Palmdale Hybrid Power PROJECT

Supplemental Responses to CEC Data Requests Set 1

Docket 08-AFC-9

**PALMDALE HYBRID POWER PROJECT (08-AFC-09)
CEC STAFF SET 1 DATA REQUESTS 28, 31 & 39 – 49**

FIGURE 41-A. SEGMENT 1
TYPICAL CITY/ACCESS/SPUR ROADS
R/W & EASEMENT
FOR SINGLE CIRCUIT T-LINE
NTS

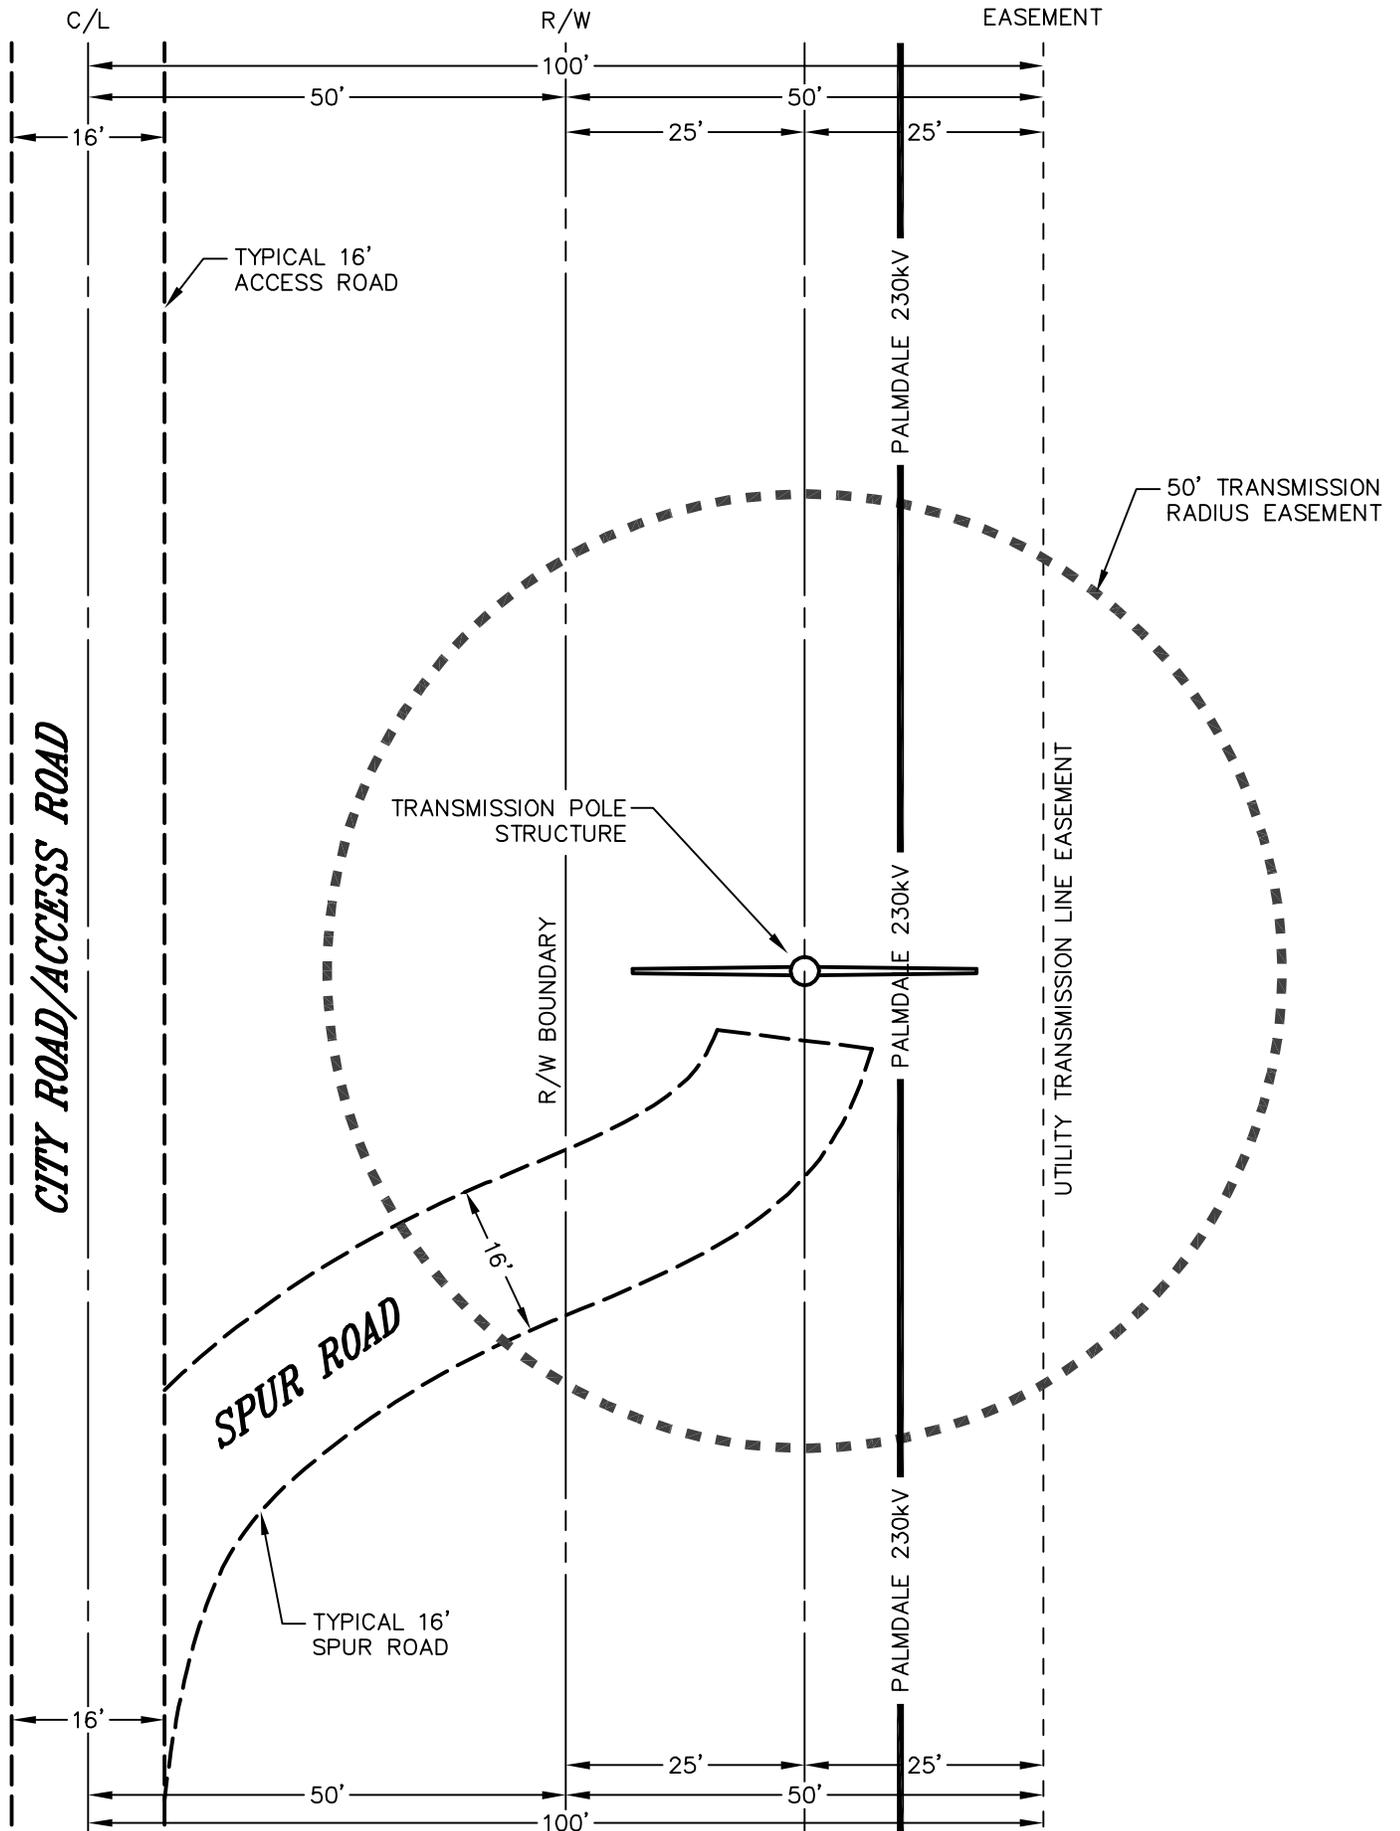
For the portions of Segment 1 that would be sited within existing rights-of-way, please specify what types of existing right-of-way would be used where these portions would be located.

- a. For example, discuss whether these existing rights-of-way would be in public roadways, other existing utility corridors, etc.
- b. Discuss whether there is sufficient room (i.e., width) within these existing rights-of-way to site the proposed 230 kV transmission line.

- a. As discussed in the response to Data Request 39, the City will acquire a new utility corridor easement that is a total of 50 feet in width. The utility corridor easement will begin 50 feet from the centerline of the street and extend outward to a point 100 feet from the centerline of

the street. Easements for the access roads will be added as needed where the edge of the street ROW and the utility corridor easement do not meet. Please see Figure DR-41A for a diagram of a typical spur road installation relative to a single circuit transmission line.

The required utility corridor easement per PAR Electric will be a minimum of 50 feet in width for transmission line Segment 1. Segment 1 is to be constructed within an unimproved rural setting. Please see Figure DR-41A. The utility corridor easement's width of 50 feet is consistent with applicable transmission line right-of-way requirements for rural and urban areas.

Figure 5 Map 3/6
 Built Environment Technical Report
 PHPP
 Palmdale, California

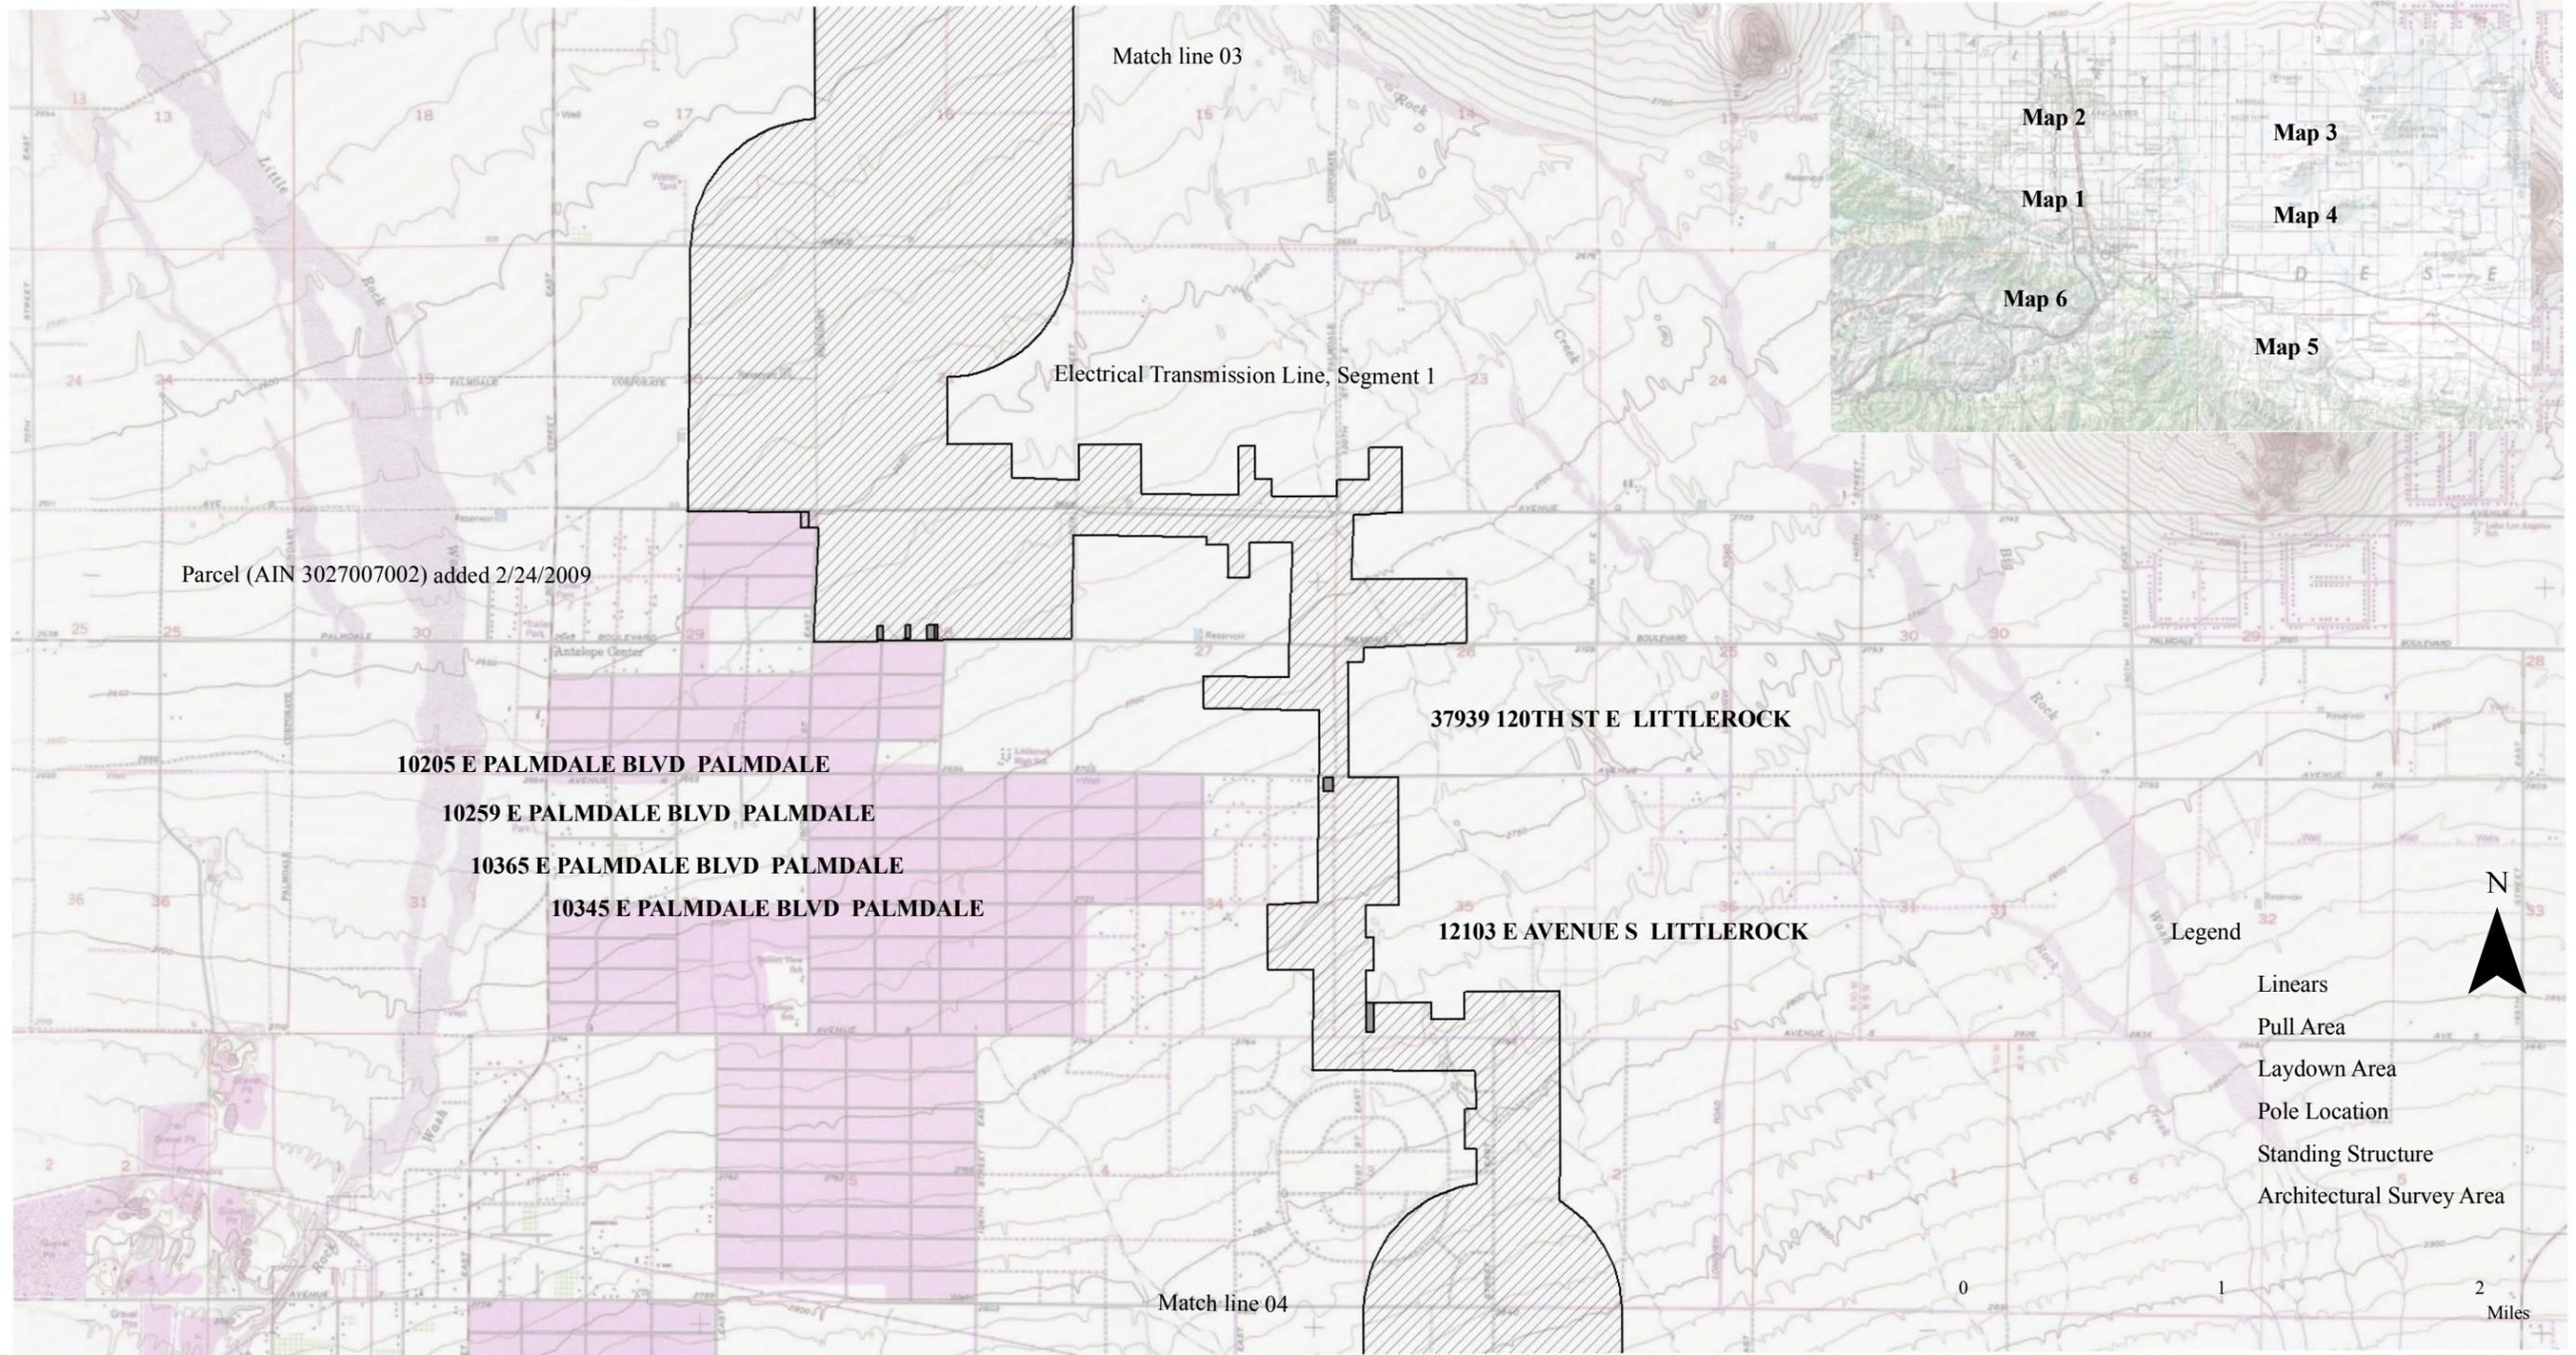
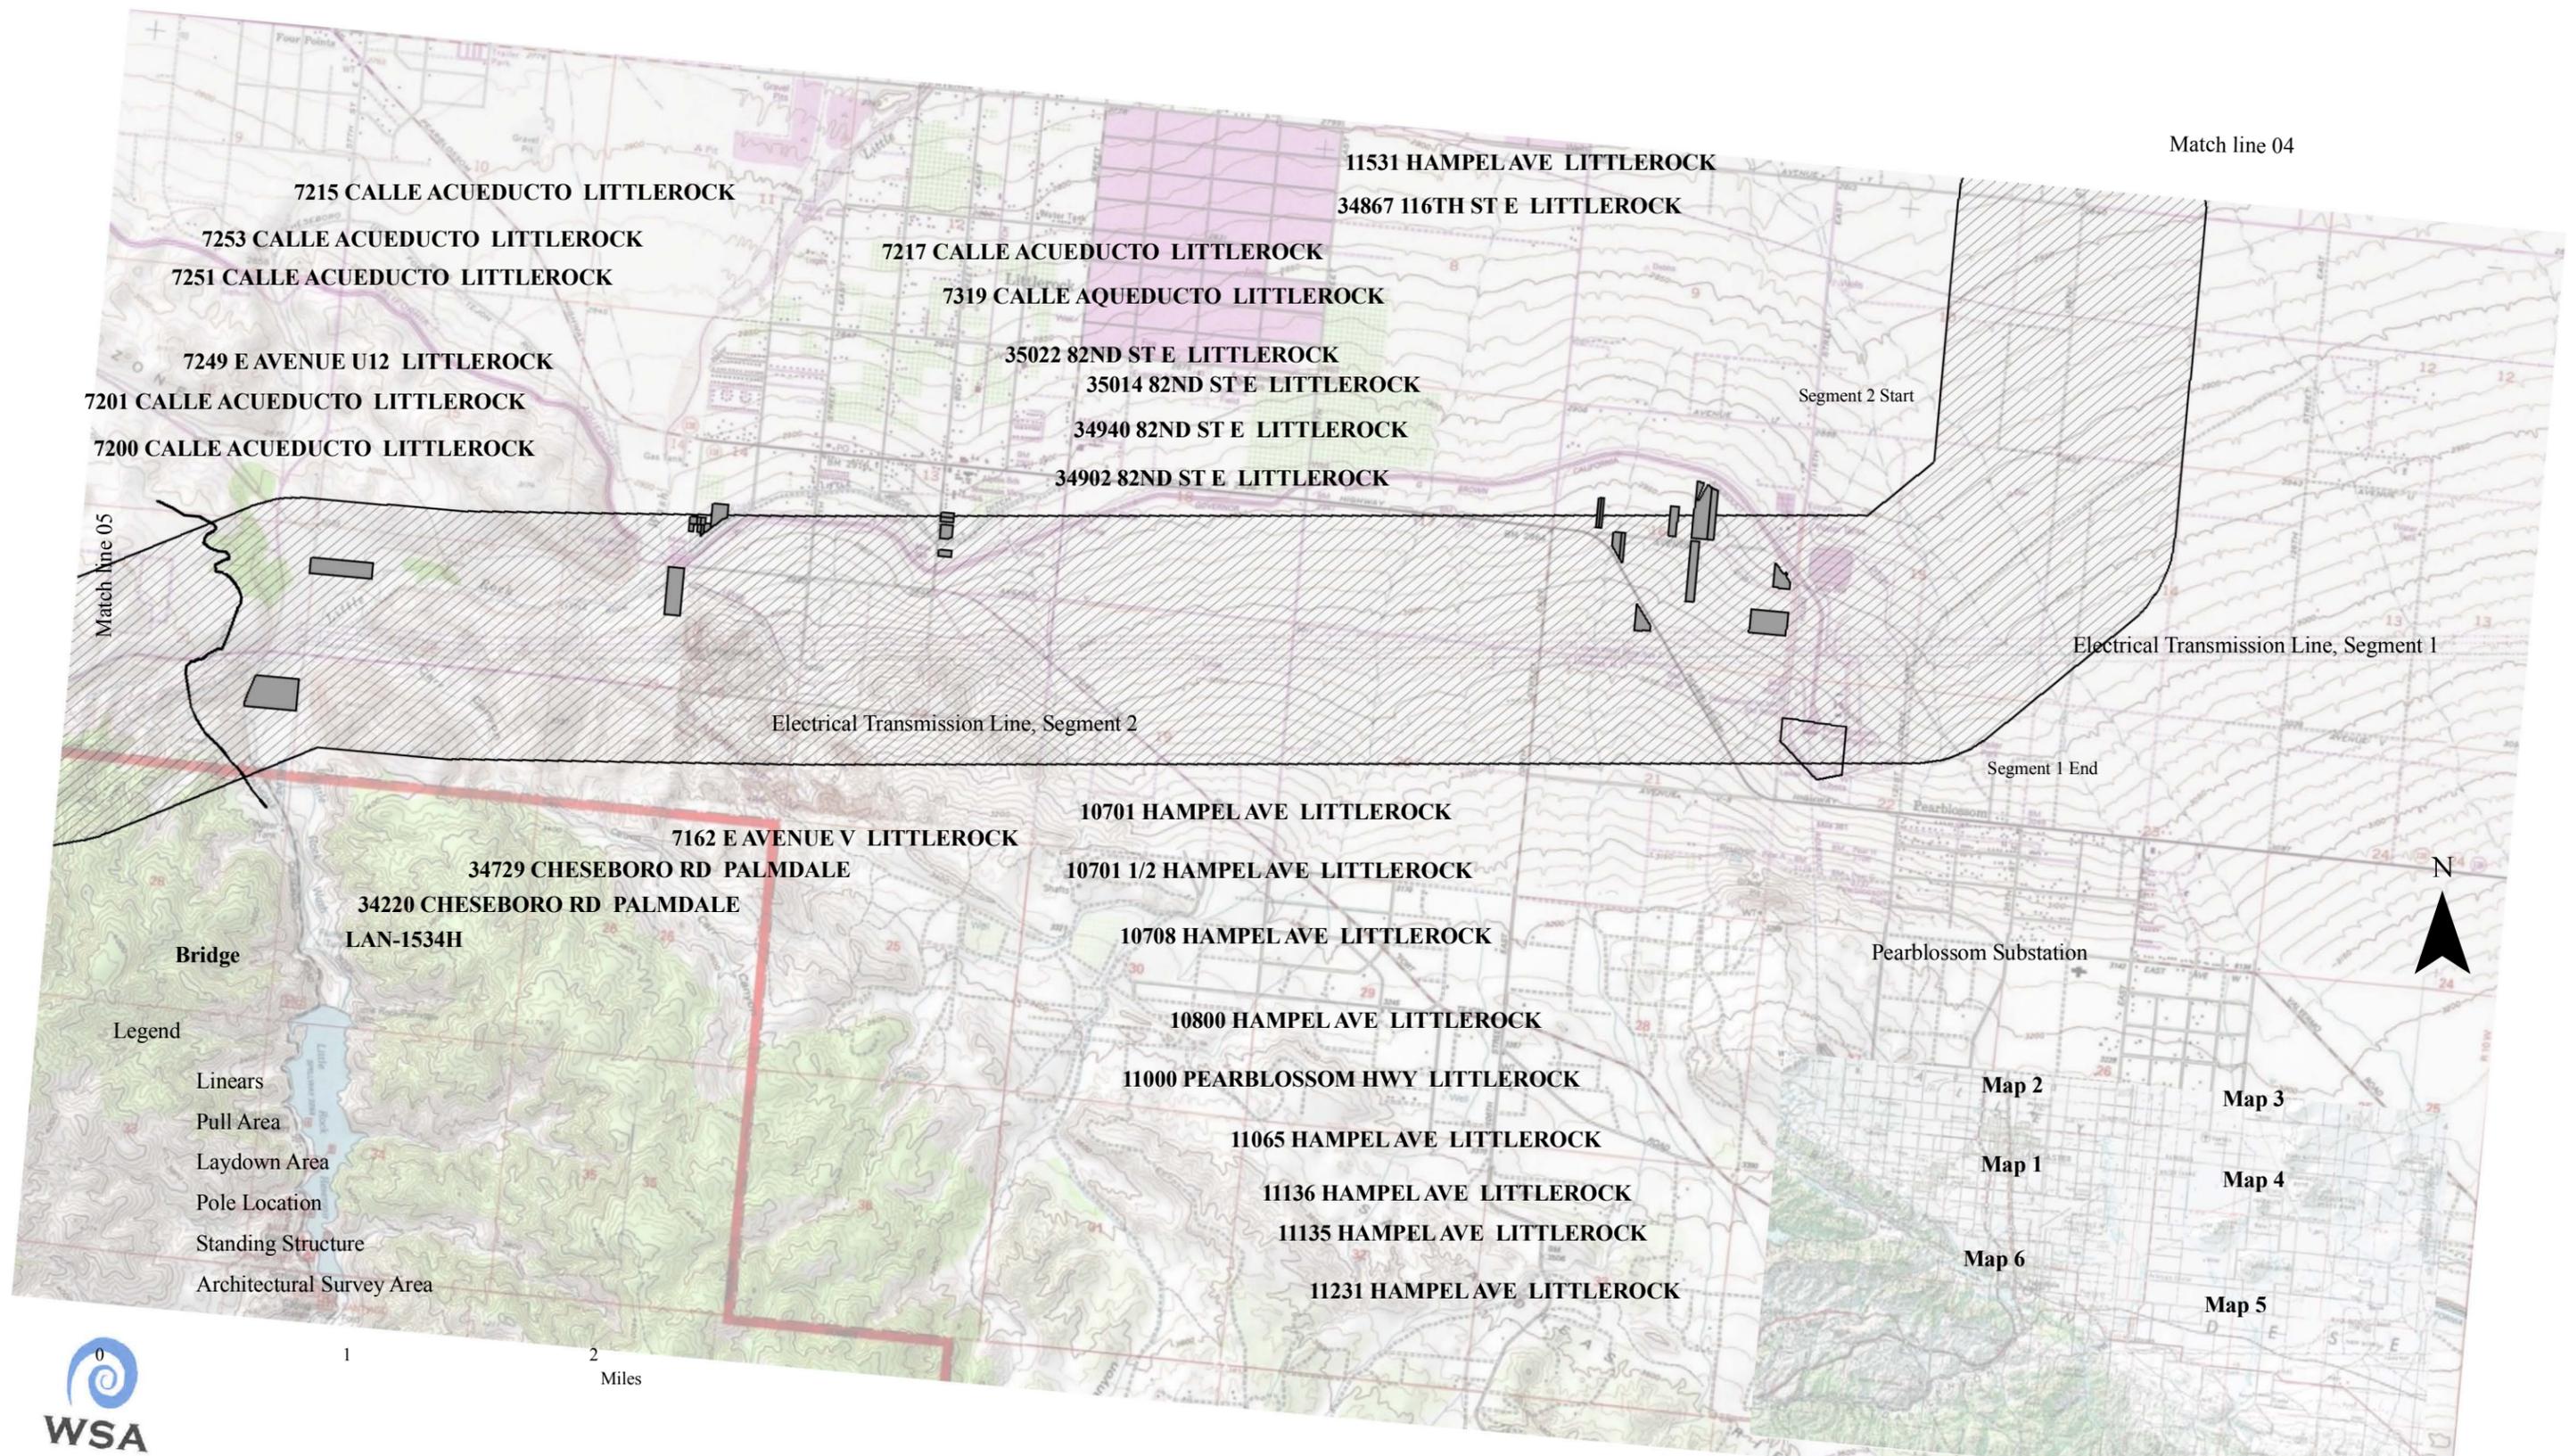
Please submit a new non-confidential Figure 5 which adds the tower locations and the pull site locations for the proposed transmission line to the plotted locations of known and newly identified built-environment resources.

The Applicant has revised the non-confidential version of Figure 5, which adds tower locations, pull site locations, and laydown areas for the proposed transmission line to the plotted locations of known and newly identified built-environment resources. The six maps comprising Figure 5 are included as an attachment at the end of this section.

The two transmission line reroutes (see response to Data Request 20), the three laydown areas, and the 22 pull site locations are all within the built environment survey area, so no new built environment surveys will need to be conducted. One of the pull sites extends into Parcel AIN 3027007002, which is outside of the original built environment surveys area. This parcel has been added to the survey area, but is vacant according to the County Assessor's data, so it will not be re-surveyed.
